AGENDA

Planning Commission Meeting
Tuesday, June 23, 2020
7:00 pm
Gardner City Hall
120 E. Main Street

PLANNING COMMISSION STAFF REPORT NEW BUSINESS ITEM No. 1A & 1B
MEETING DATE: JUNE 23, 2020
PREPARED BY: ROBERT CASE, PLANNER

PROJECT NUMBER / TITLE: FDP-20-02 Final Development Plan and FP-20-02 for Prairie Trace Meadows First Plat

STREET TREE & BUFFER LANDSCAPE PLAN
L1.0

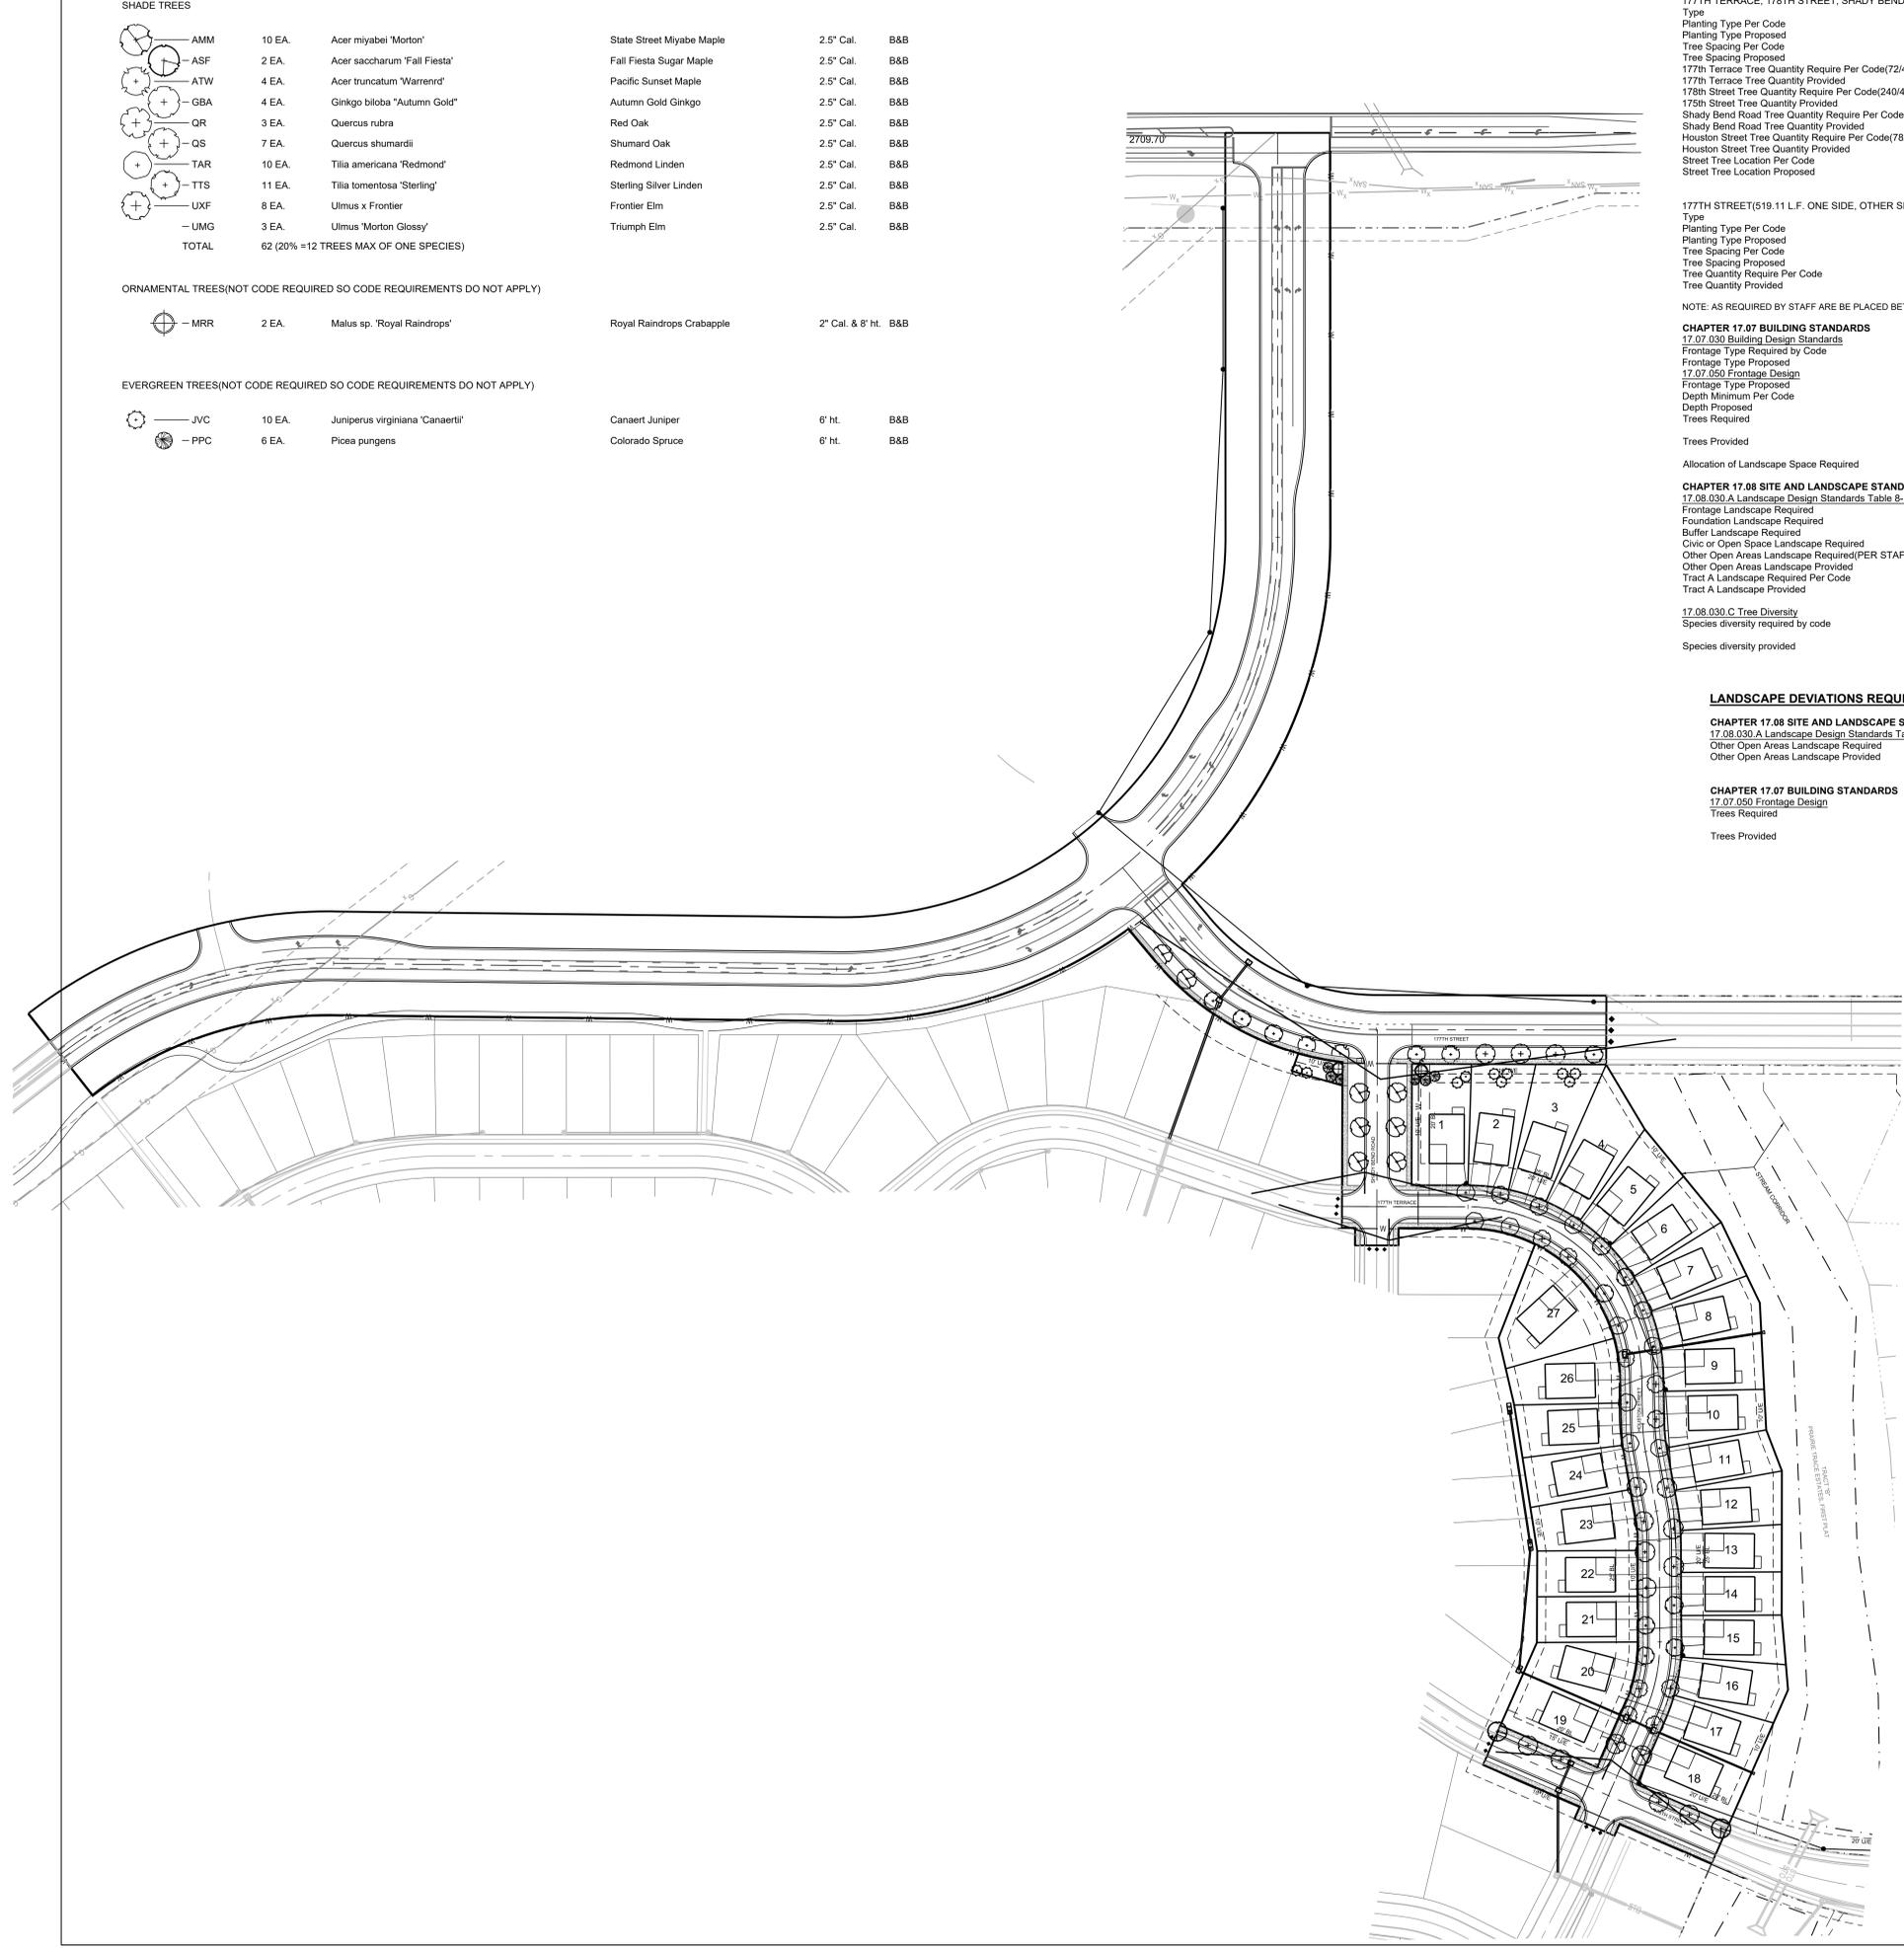
Staff Comment: The tree(s) can be located anywhere on the lot as it does not have a location requirement. All of the proposed lots in this phase are under 10,000 sf which would require 1 tree to comply with this standard with the exception of Lot 27 which is 11,003 sf. The applicant proposed 27 large open space general trees, which is 1 per lot. Staff recommends approval of this deviation request.

Staff Comment: The shrub(s) can be located anywhere on the lot as it does not have a location requirement. The Staff supports the deviation request for 2 shrubs per lot.

Staff Comment: The standard is for one small tree for every 50' of frontage; OR one medium or large tree for every 100' of frontage, the applicant provided a landscape proposal that proposes the use of large street trees (approximately 1 adjacent to each lot). The applicant has indicated that with a large street tree and small front yard, the same goal for shade is achieved, staff supports a consistent standard of one tree per lot and recommends approval of this deviation.

1. Revise the landscape plan to update the information regarding 177th Street to be a Collector-Standard Street.
2. Potential condition regarding deviation #3 - remove condition if deviation to omit frontage trees is to be granted.

FINAL PLAT OF PRAIRIE TRACE MEADOWS, FIRST PLAT

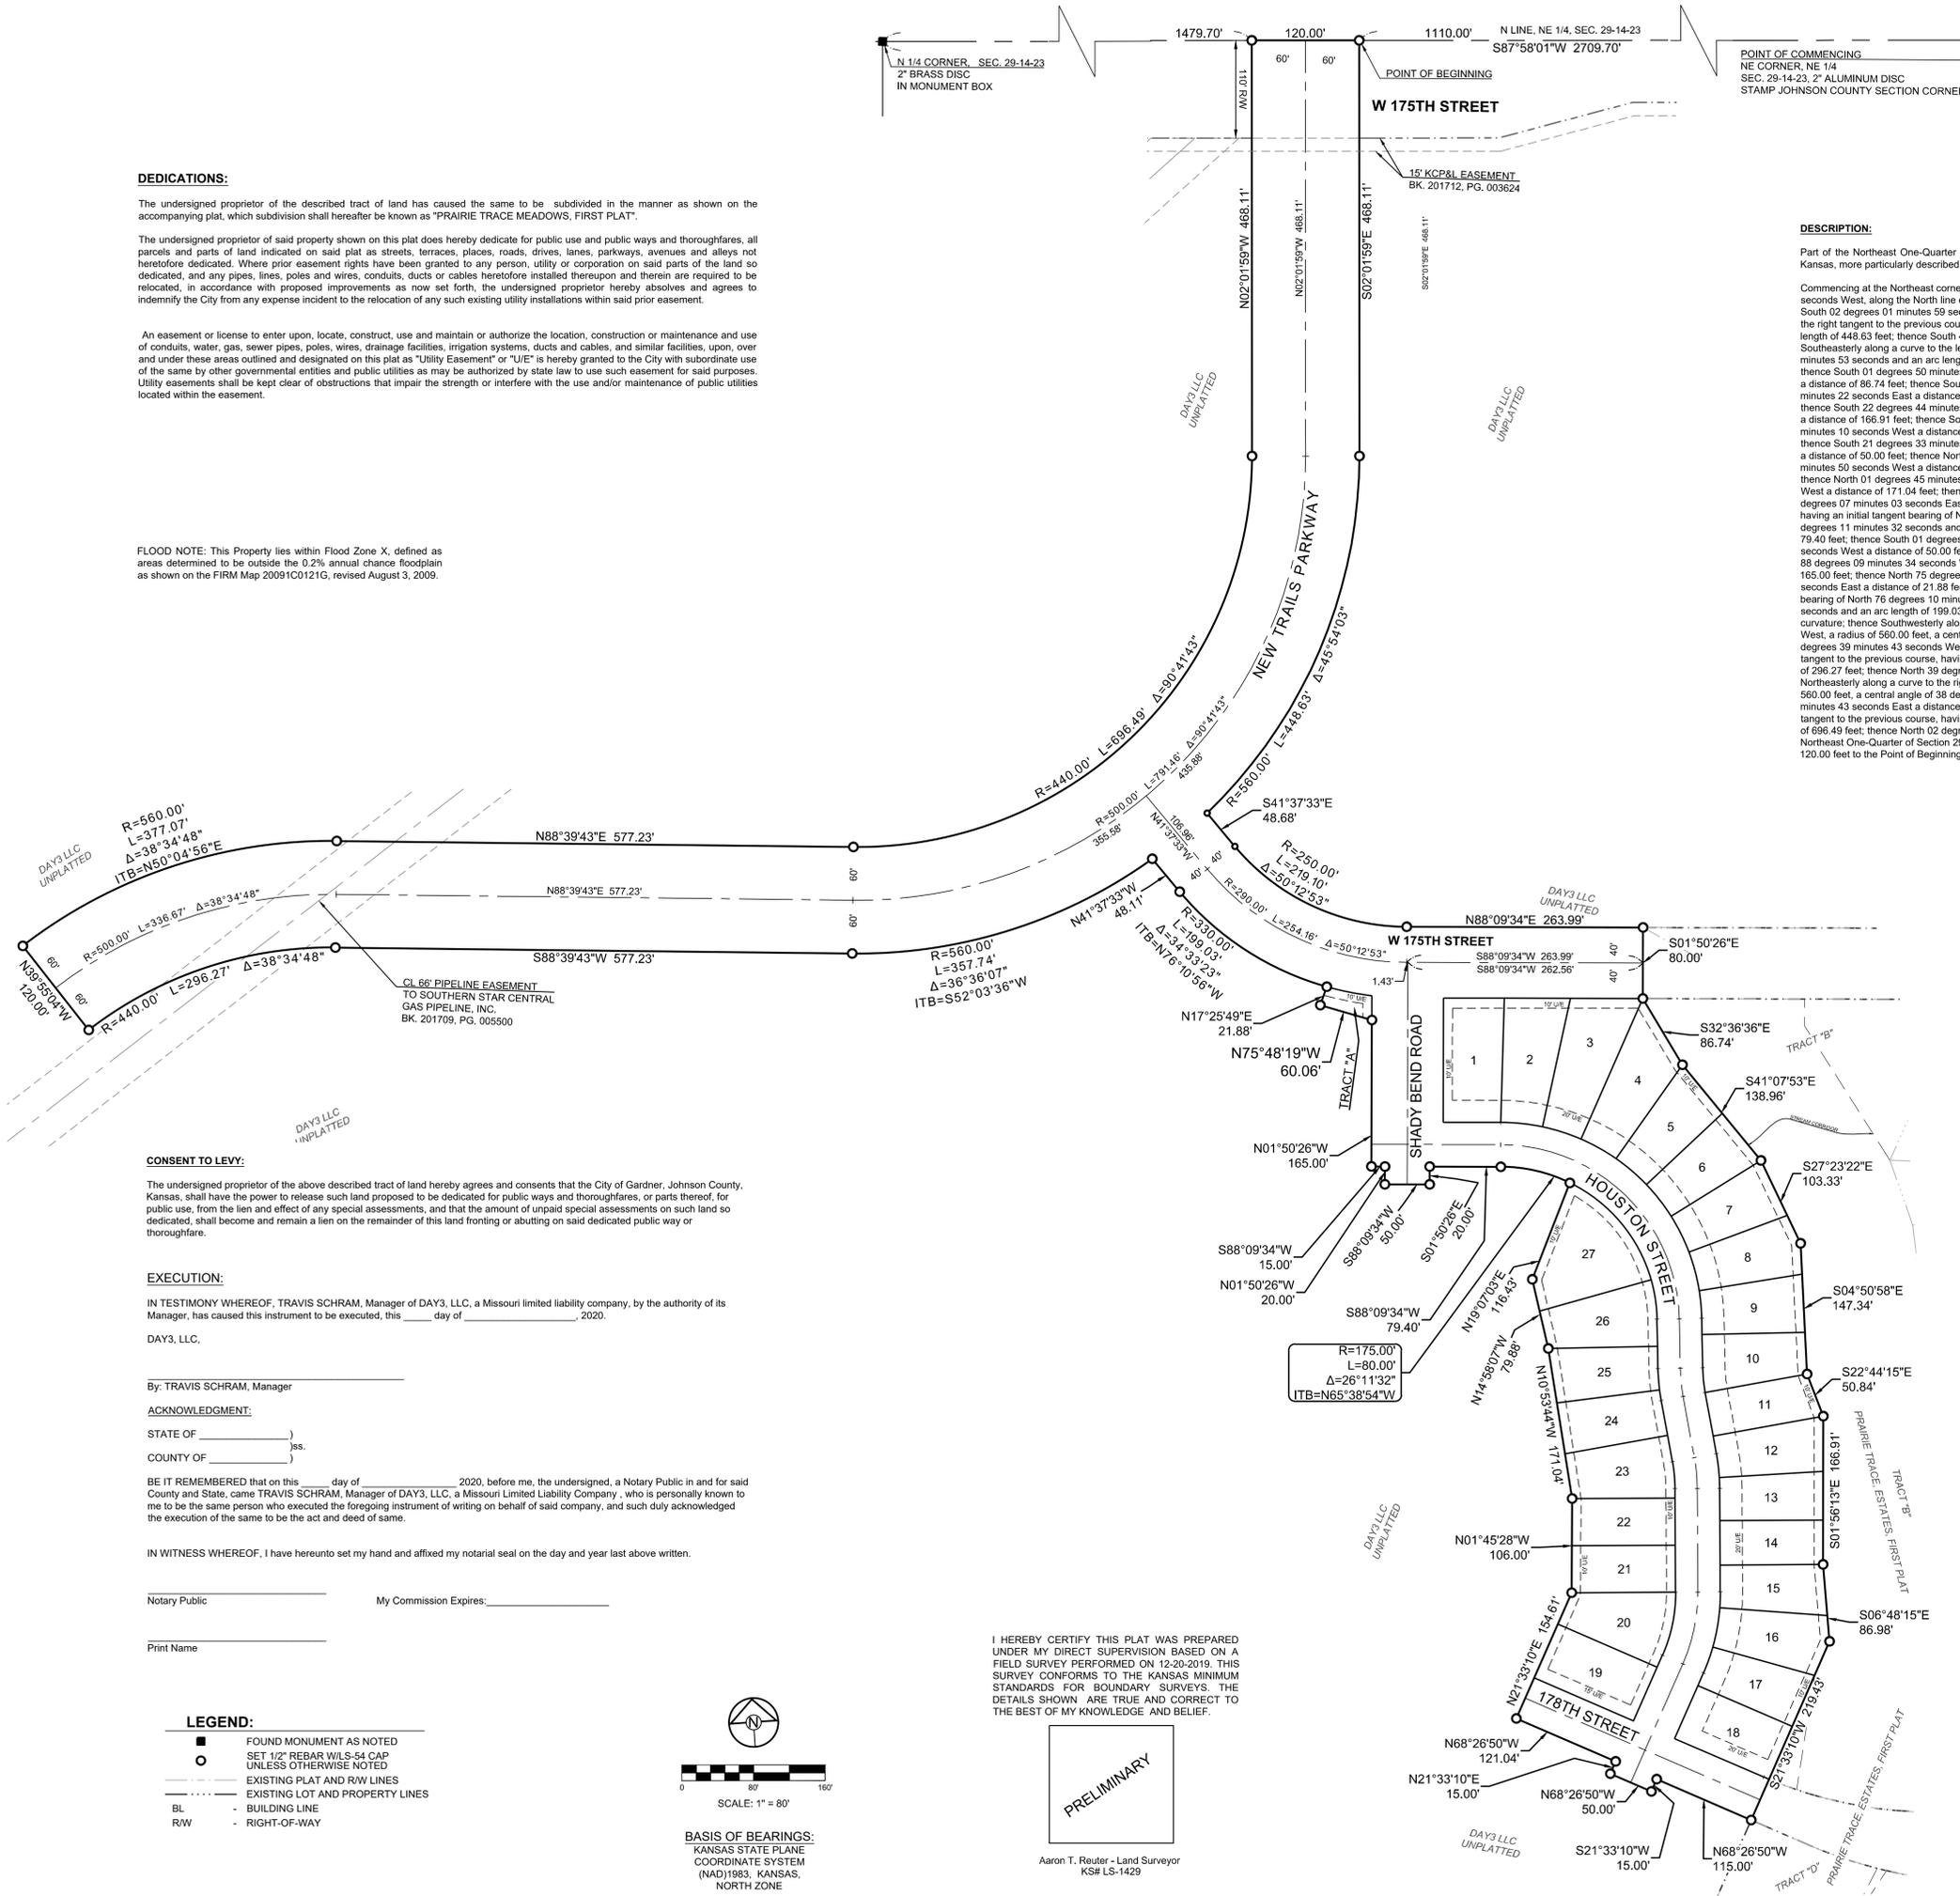
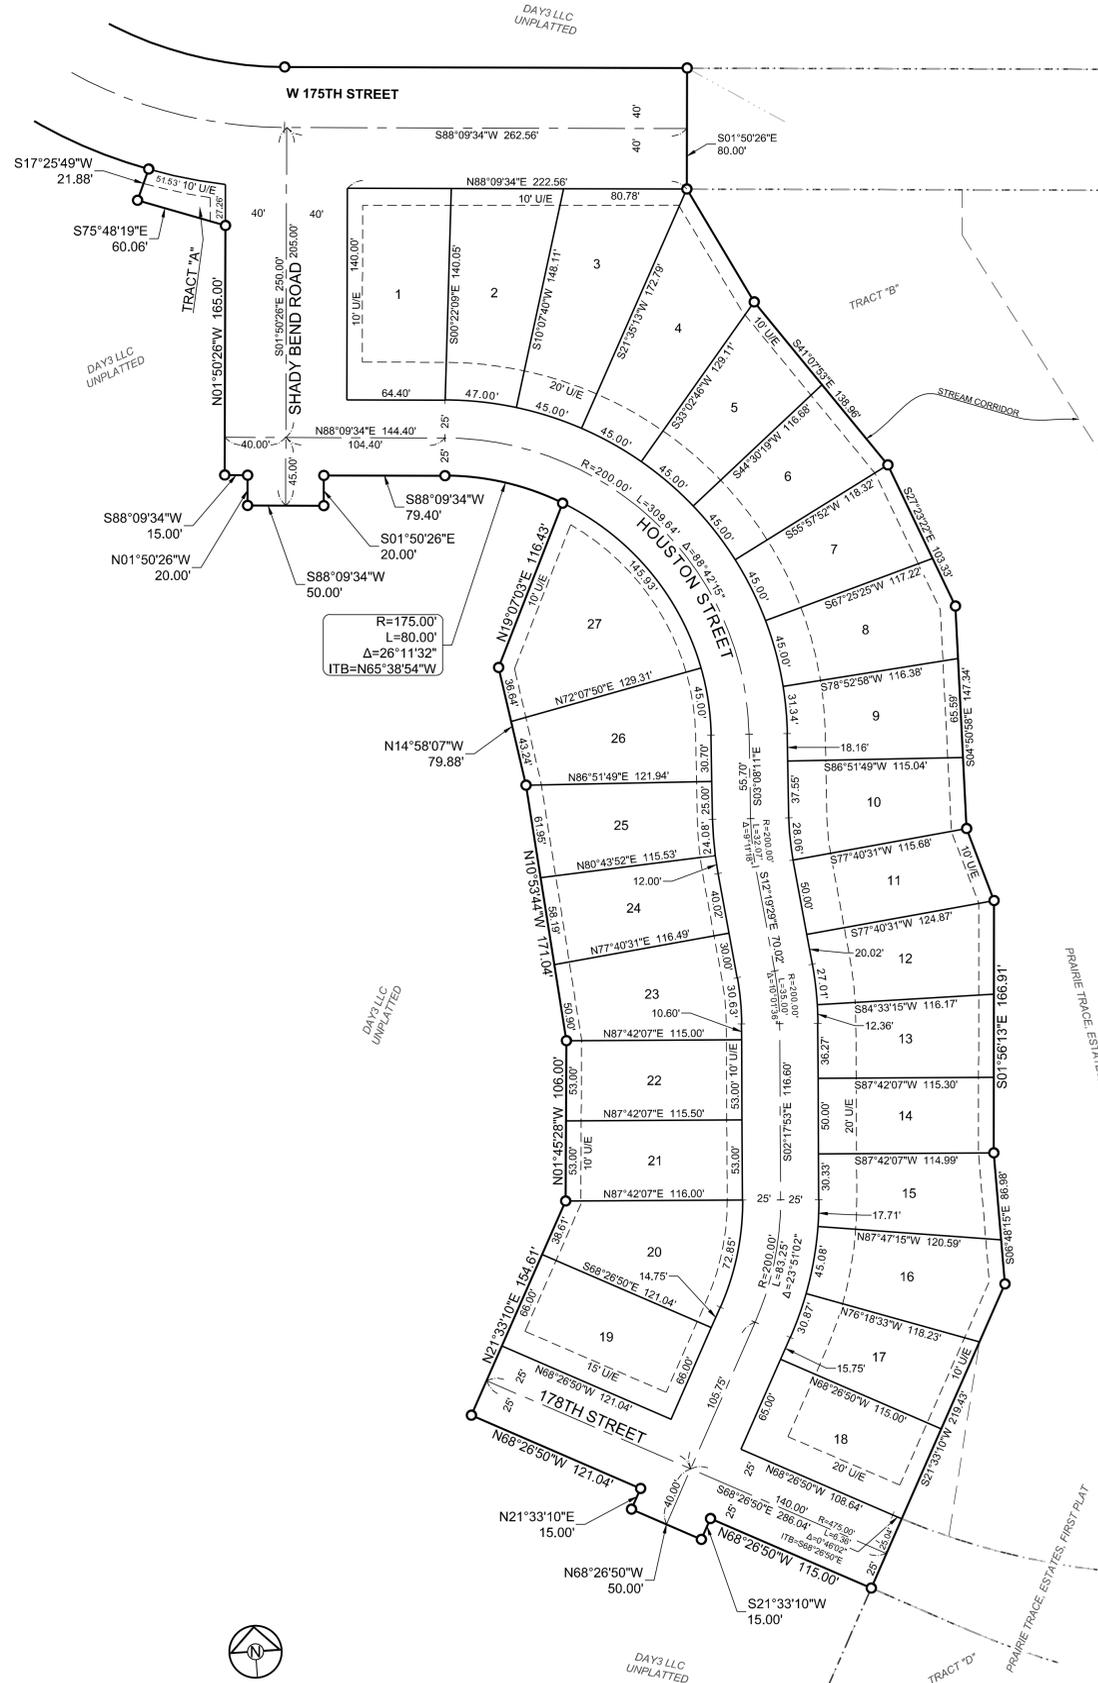
1. Revise the plat to provide rear lot line dimensions for the lots on the east side of Houston Street.
2. Revise the plat to move the note about Tract A so it does not overlap lot area information.

3. Revise the plat to show utility or drainage easements between Lots 8 and 9, Lots 17 and 18, and Lots 19 and 20.
4. Provide a written agreement that Southern Star has reviewed the plans and agrees to the proposed street crossings and 10' concrete trail and associated easements to be located within their 66' gas pipeline easement.
